Amendments to the Drawings:

Appl. No. : 10/671,157
Amdt. dated October 17, 2005
Reply to Office Action of July 1, 2005

Remarks/Arguments

Fig. 3

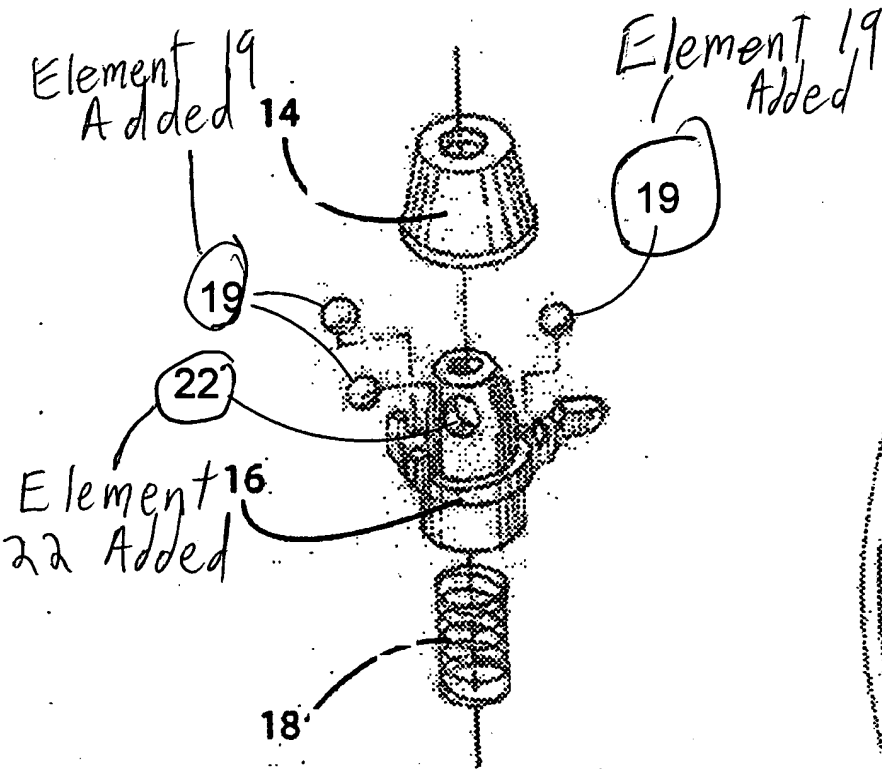
The numeral "19" was added to Fig. 3 at two places, Fig. 5 at two places, Fig. 6a at one place, Fig. 6b at two places, and Fig. 7 at two places.

The numeral "22" was added to Figures 3, 5, and 7.

Paragraph [0037] of the specification was amended to insert the number "22" after "three openings". Figures 3, 5, and 7 now have the numeral 22 to indicate one of the three openings. These amendments are intended to show the feature of the three openings specified in the claims.

The numeral "19" was added to Fig. 3 at two places, Fig. 5 at two places, Fig. 6a at one place, Fig. 6b at two places, and Fig. 7 at two places. The numeral "19" was added to identify more clearly the three ball bearings.

The numeral "22" was added to Figures 3, 5, and 7 to identify more clearly the three openings for the three ball bearings.

Fig. 6a

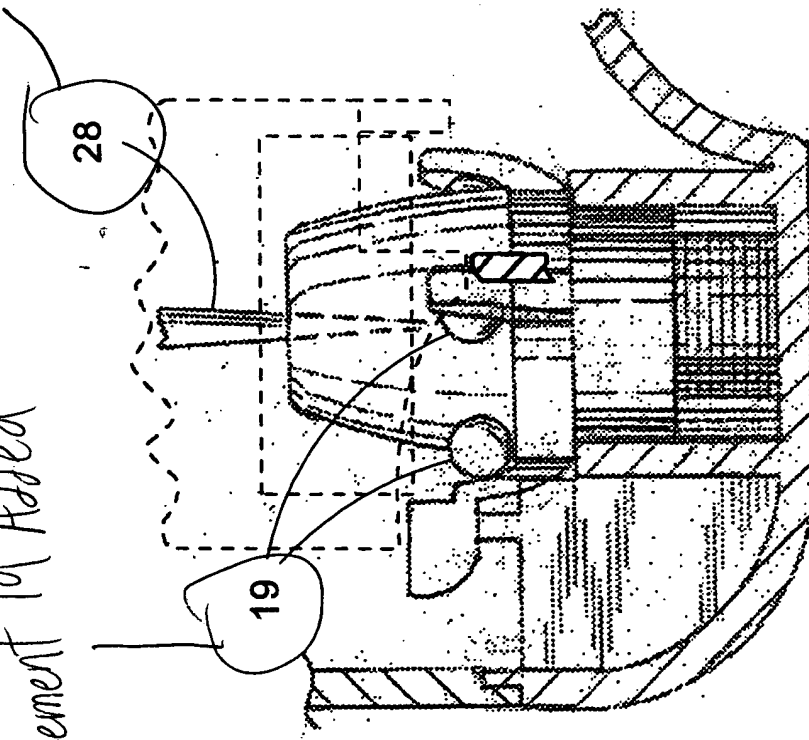
Paragraphs [0037], [0038], and [0039] of the specification were amended to insert the number "28" after "shaft" to support additions to the drawing figures. Figures 5, 6a, 6b, and 7 now have the numeral "28" to indicate the tack shaft. These amendments are intended to show the feature of a tack shaft specified in the claims.

The numeral "28" was added to Figures 5, 6a, 6b, and 7 to identify more clearly the shaft of the tack.

Element 19 Added

Element 28 Added
